**PARK CITY PLANNING DEPARTMENT ADMINISTRATIVE HEARINGS MEETING
SUMMIT COUNTY, UTAH
July 15, 2021**

Planning Department Staff Report

Subject: 1008 Lowell Avenue
Application: PL-21-04841
Author: Browne Sebright, Planner II
Date: July 15, 2021
Type of Item: Administrative -- Historic District Design Review

Planning Department Staff Report

Exterior Elevations

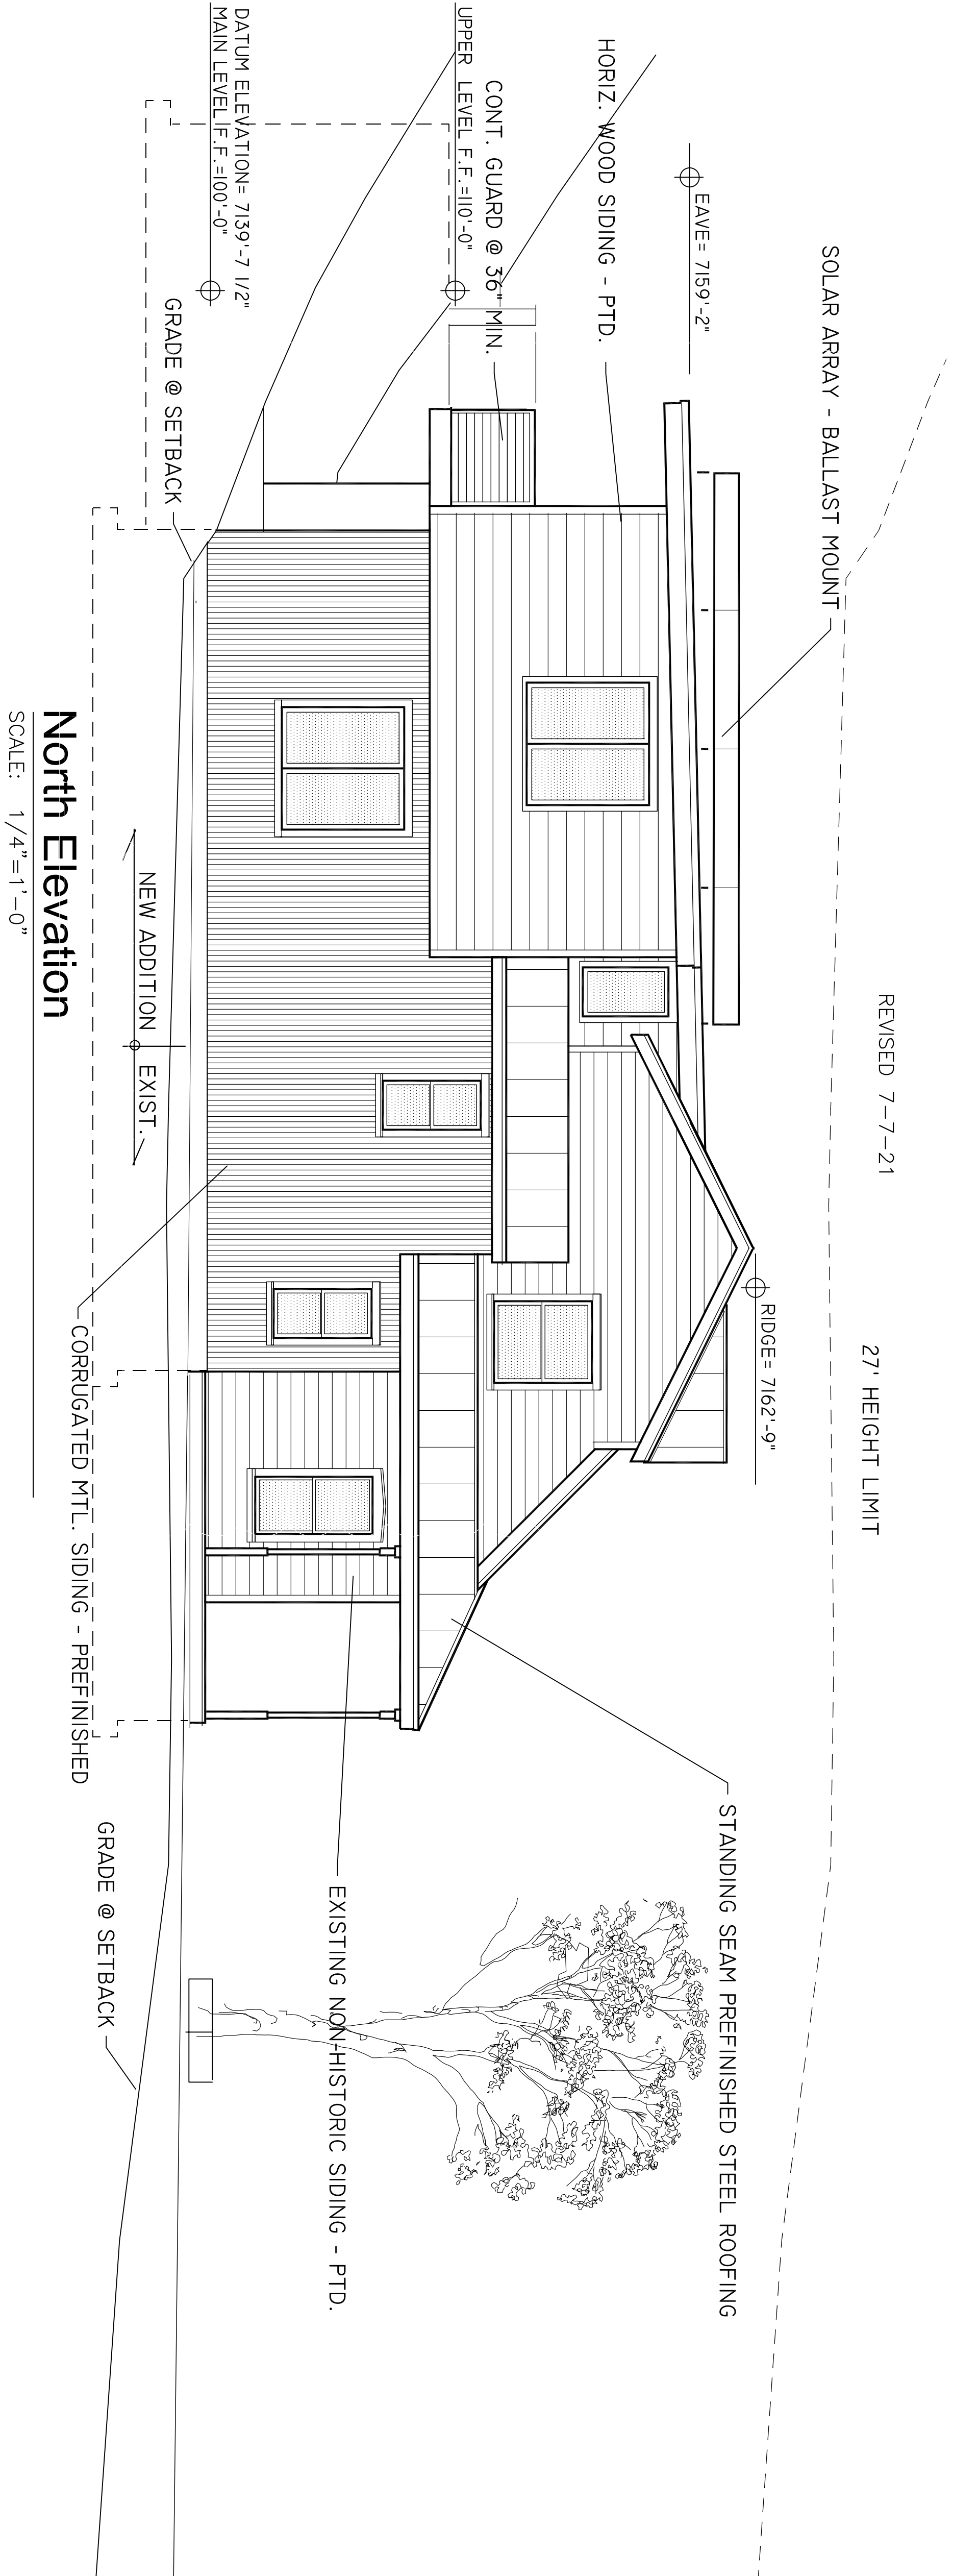
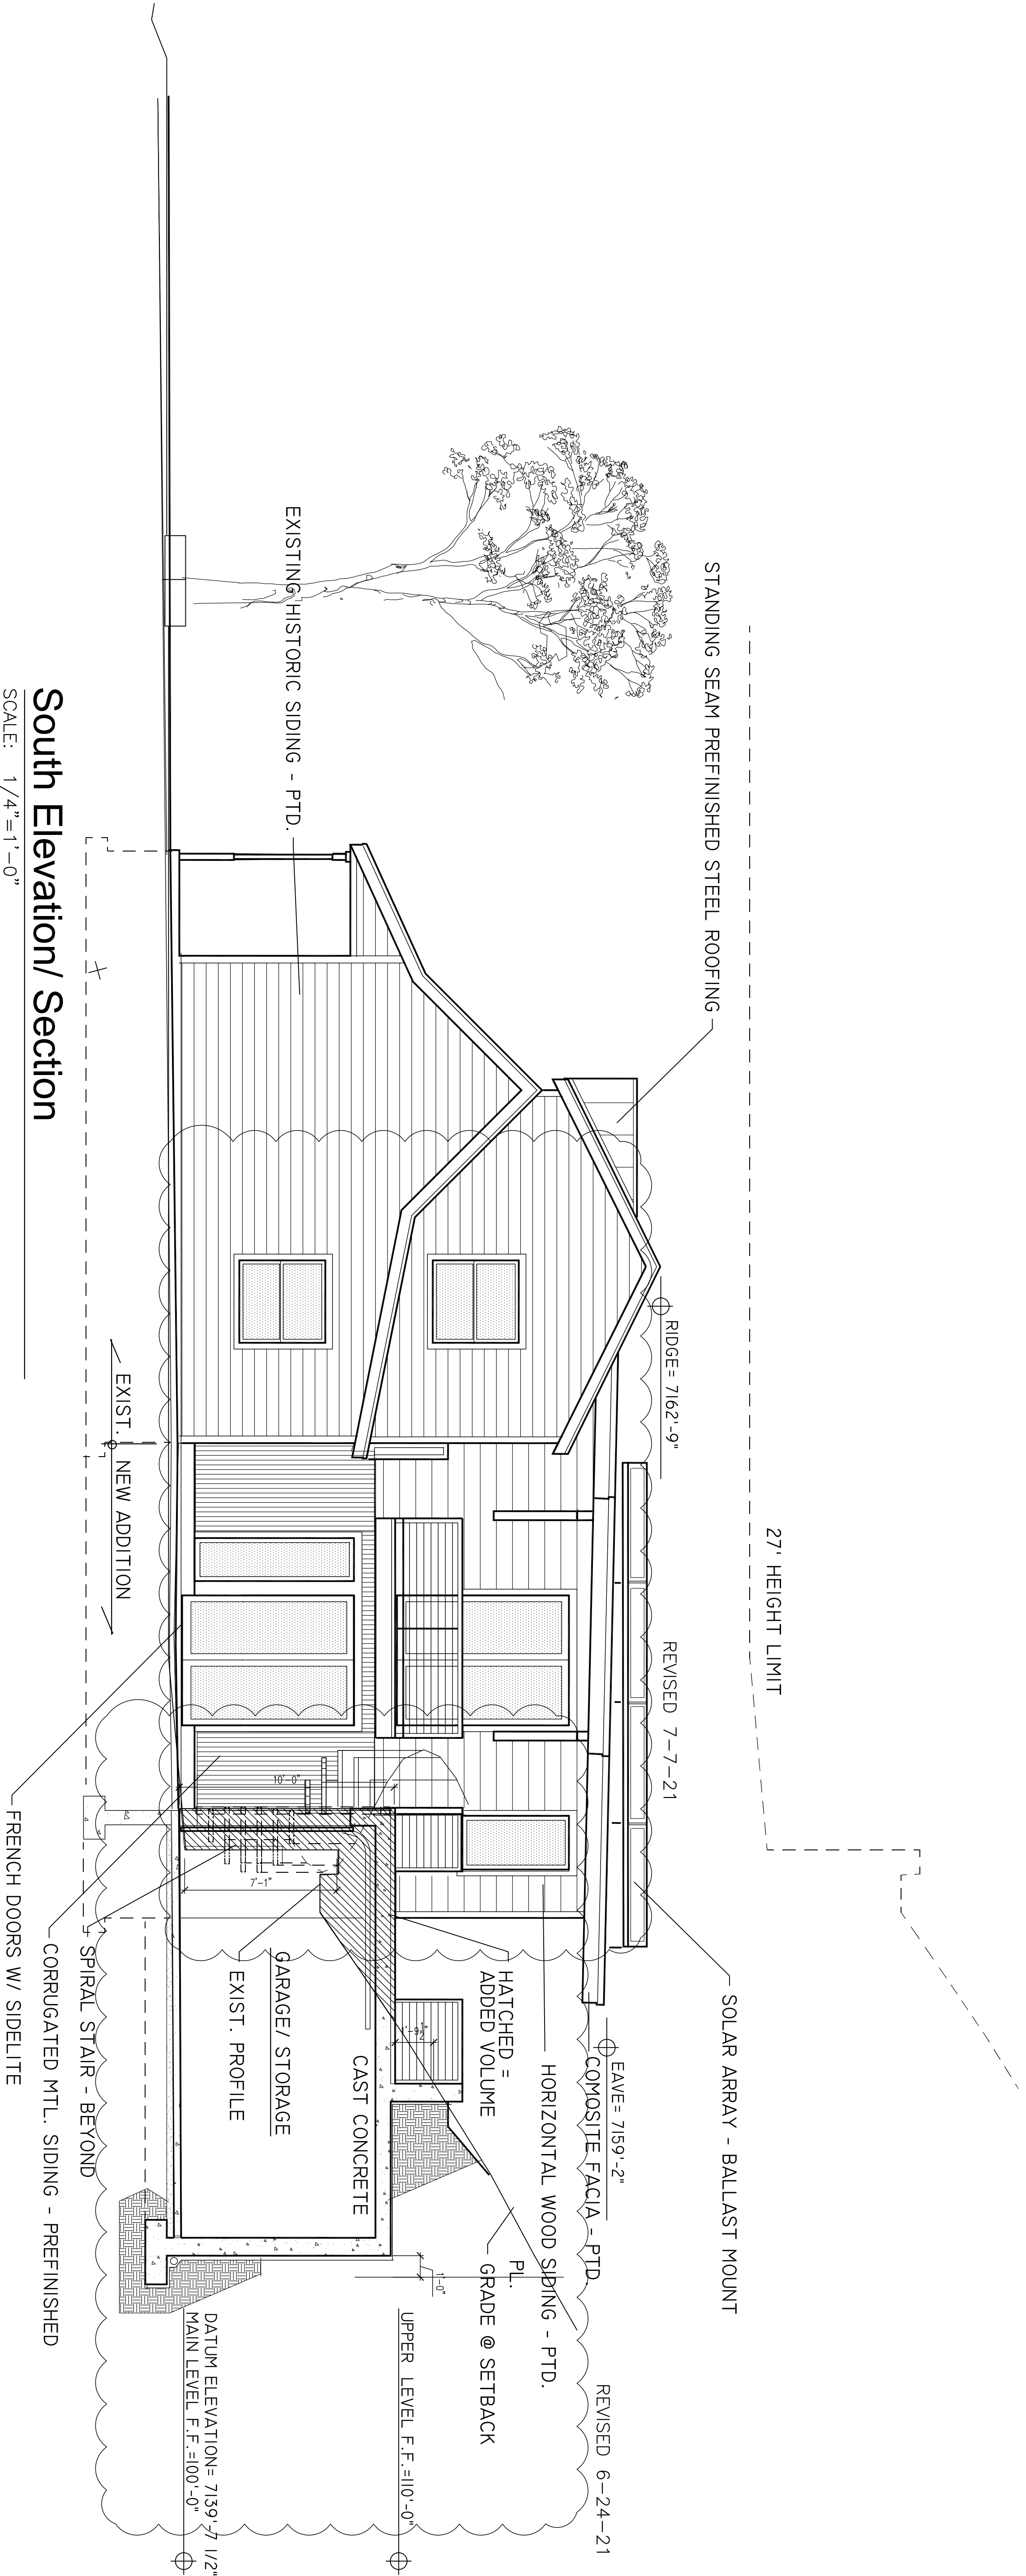
The Applicant met with staff and the Applicant updated the plans to remove the cross-gable roof feature along the front addition so the addition roof facing Daly Avenue mirrors the Historic roofline; removing alternate siding along the southern façade to create consistency between the solid-to-void ratio and the siding of the solid material, increasing uniformity of the siding on the addition, decreasing the pavement in the front yard and increasing the landscaped area, and changing the proposed siding material to comply with the requirements of LMC [§ 15-13-2](#).

7. The Applicant met with staff and the Applicant updated the plans to remove the cross-gable roof feature along the front addition so the addition roof facing Daly Avenue mirrors the Historic roofline; removing alternate siding along the southern façade to create consistency between the solid-to-void ration and the siding of the solid material, increasing uniformity of the siding on the addition, decreasing the pavement in the front yard and increasing the landscaped area, and changing the proposed siding material to comply with the Design Guidelines.
